Amendment No. 2 to Subsidence Management Plan for Sydney Water Potable infrastructure due to shortening of LW S4A and planned mitigation measures at creek, Remembrance Drive and Main Southern Railway crossings prior to influence of LWs S4A to S6A (Revision B)

Please be advised that a minor amendment can be made to the Management Plan, which is titled *MSEC1193-04 SIMEC Mining – Tahmoor South Longwalls S1A to S6A – Management Plan for potential impacts to Sydney Water Potable Water Infrastructure, Revision B*.

Figure 1 Locations of Gibault Joints on both sides of Creek 2

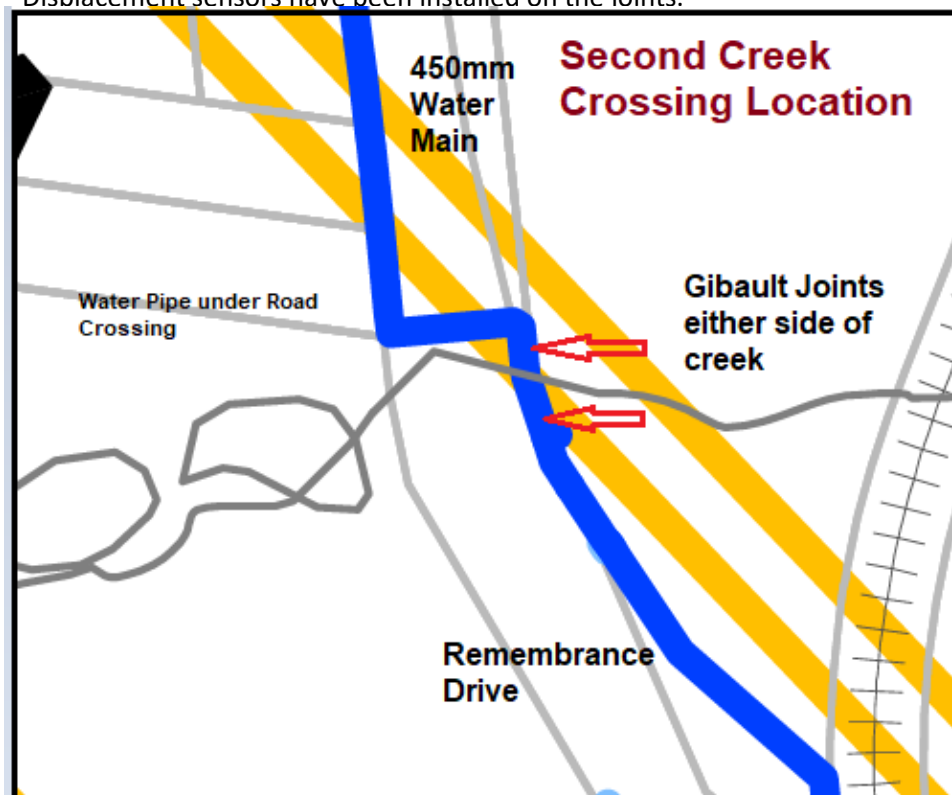
Plan. The site has been imaginatively named Creek 2 for ease of reference and its location is shown in Figure 1. The following controls are in addition to the risk controls for the majority of the water main.

- Installation of Gibault expansion joints on both sides of Creek 2.
- Displacement sensors have been installed on the joints.

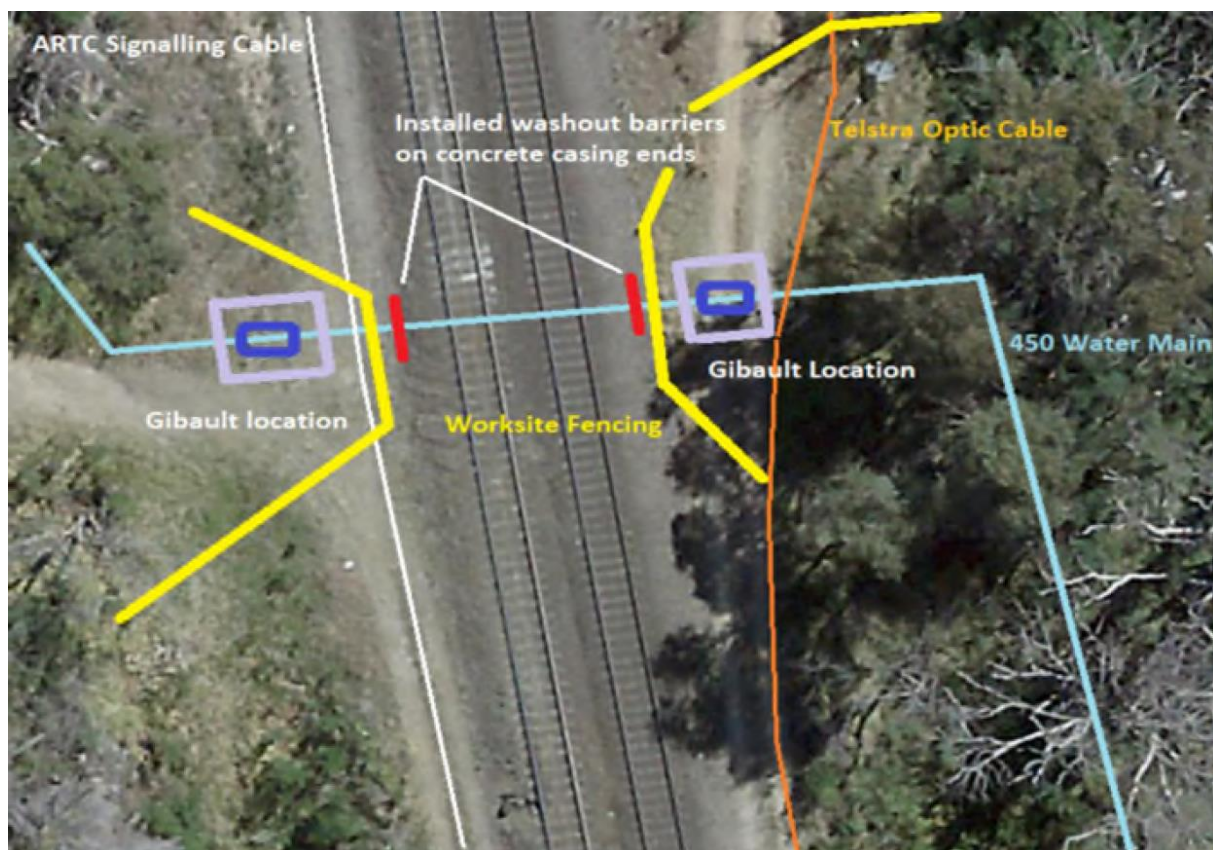
In light of the shortening of LW S4A, Tahmoor Coal and Sydney Water have agreed to implement the following reasonably practicable risk controls at the creek crossing site due to the mining of LWs S4A to S6A, which are in addition to the risk controls for the majority of the water main, as described in the Management Plan.

- Installation of Gibault joints on both sides of the crossing at Creek 3, prior to the influence of LW S5A (subject to confirmation of the LW S5A mine plan).
- Displacement sensors will also be installed on the joints.

The two Gibault joints have a combined capacity of accommodating 100 mm of closure in addition to the existing capacity of the spigot and socket CICL joints to accommodate ground closure. The total combined capacity is estimated to be more than twice the capacity of the predicted total closure at the crossing. The Gibault joints can also be re-cut and reset in the event that increased closure develops at the site.

Figure 10 Plan of Railway water main crossing at 100.380 km

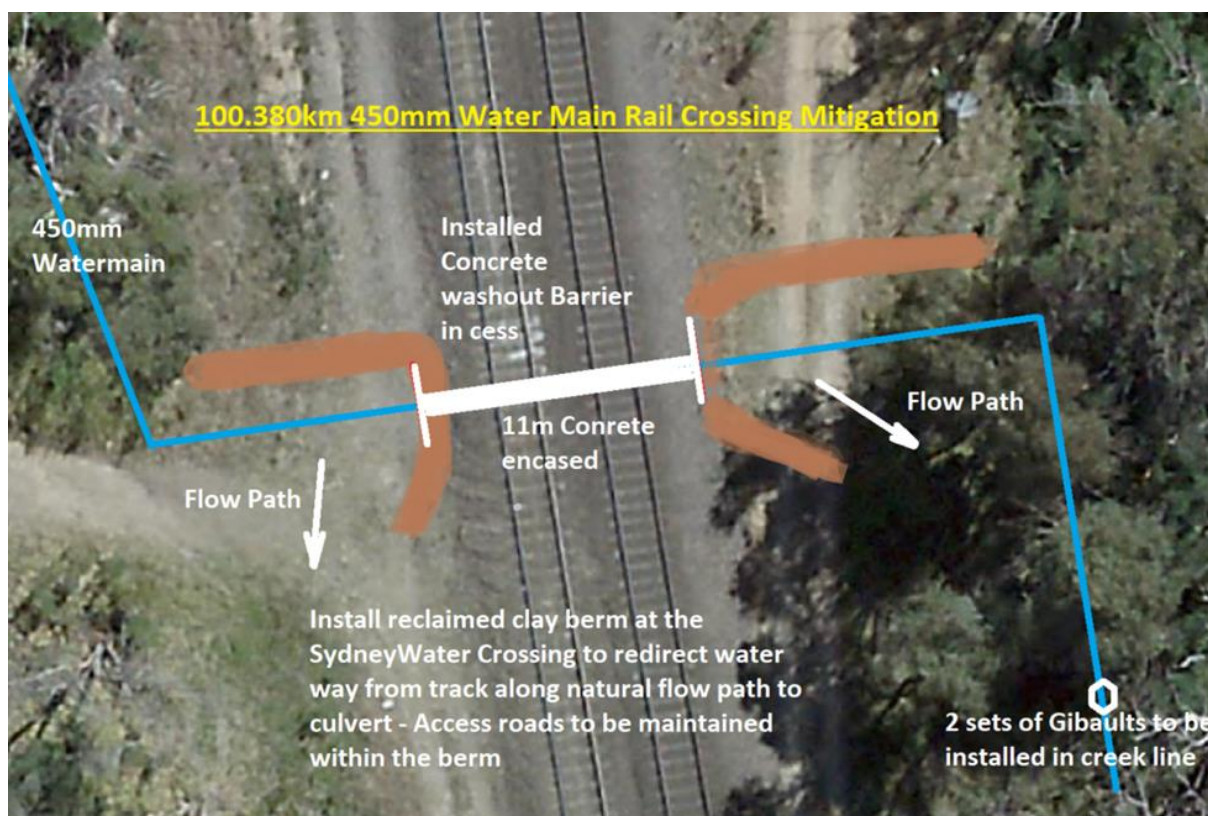
- Site investigations to confirm as-built construction of the railway crossing;
- Identification of potential location for installing Gibault joints and placement of sand bedding above pipework, if required in future based on actual observations;

- Installation of concrete washout barrier above railway crossing;
- Construction of earth berms to direct water away from railway track, as shown in Figure 10;

- Installation of Gibault joint on north of creek crossing at Creek 3, prior to the influence of LW S5A (subject to confirmation of the LW S5A mine plan). The Gibault joint will reduce the potential for impacts on the right angle bend at the eastern (Down) side of the railway crossing;

- Installation of additional survey marks in local 3D around the crossing; and
- Daily visual inspections of the pipeline crossing by Tahmoor Coal’s Rail Maintenance Contractor during periods of active subsidence during the mining of LWs S4A to S6A.

Drawing No. MSEC1395-01

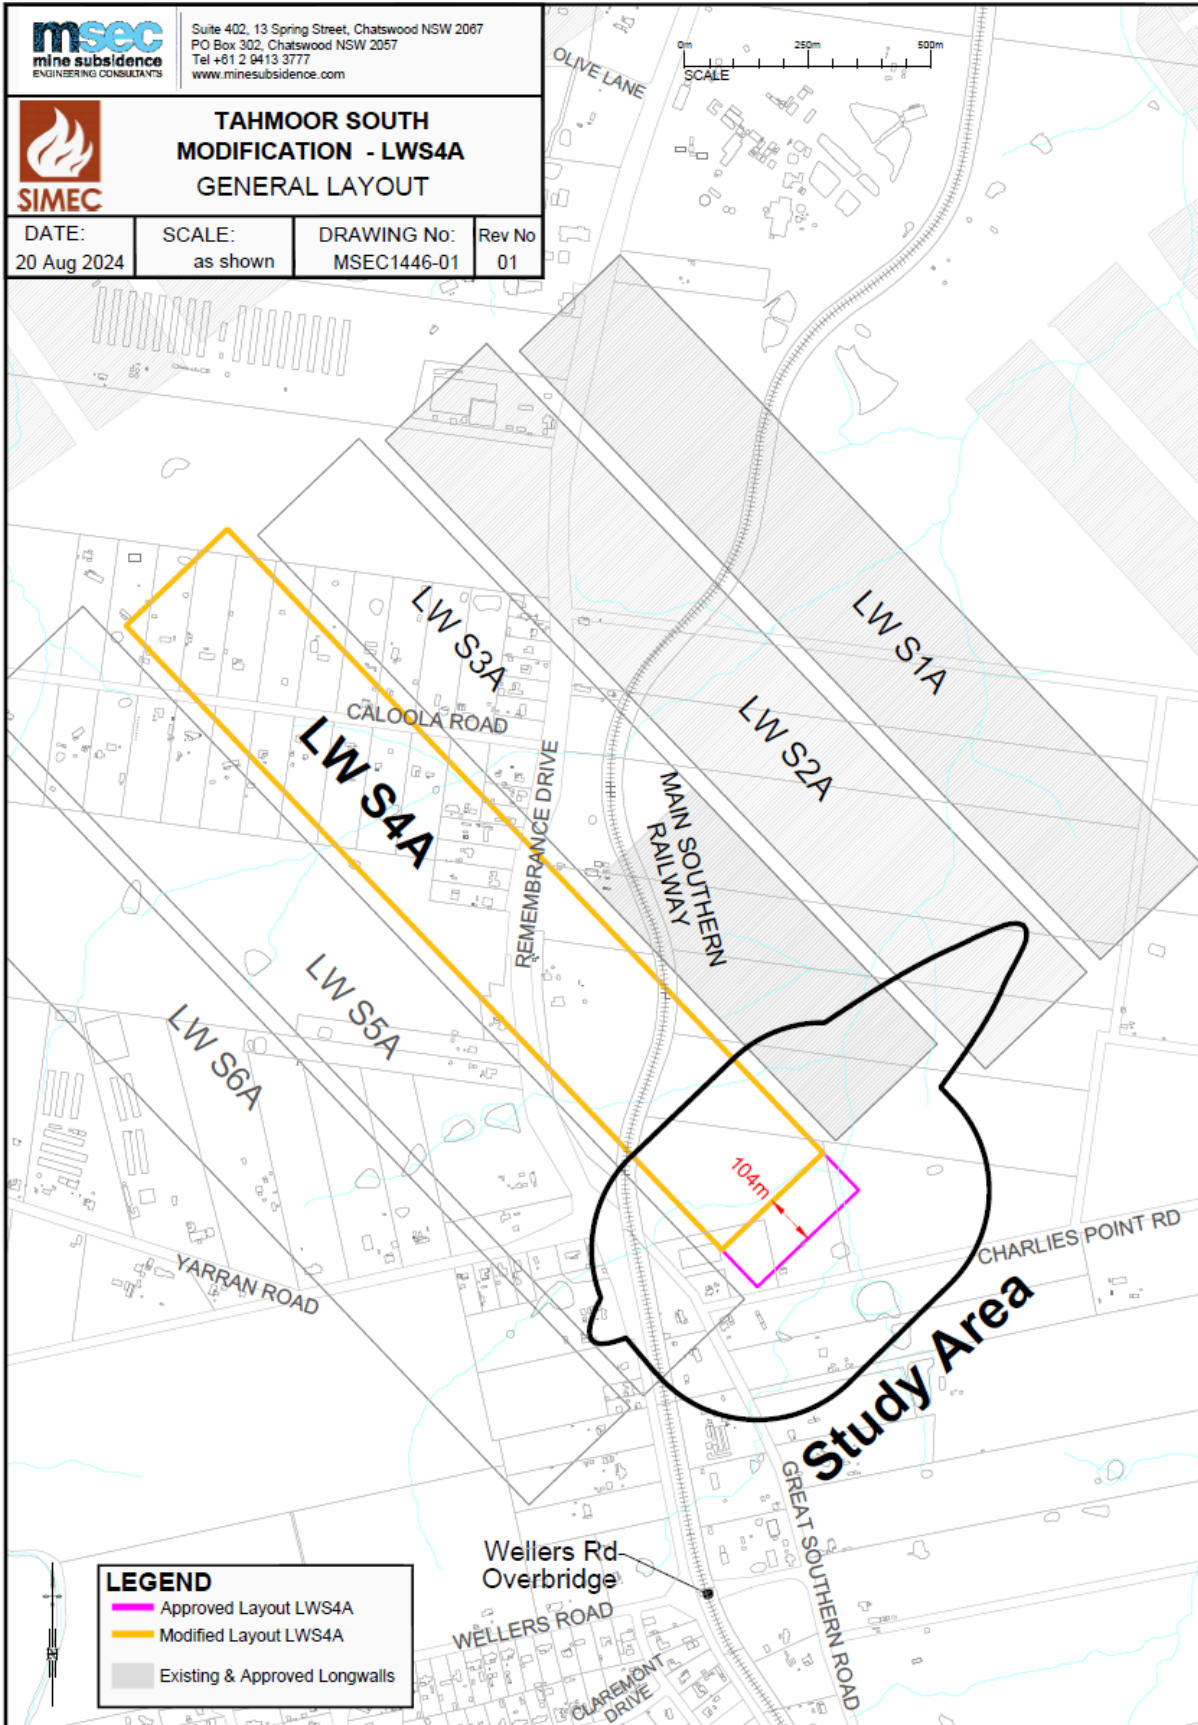
Tahmoor Coal has shortened LW S4A by approximately 104 metres at the commencing end, as shown in Drawing No. MSEC1446-01. The effect of the change is to very slightly reduce the amount and extent of subsidence that will be experienced along Sydney Water infrastructure along Remembrance Drive and Great Southern Road, including at the water main crossing beneath the Main Southern Railway, as shown in Drawing No. MSEC1446-07.
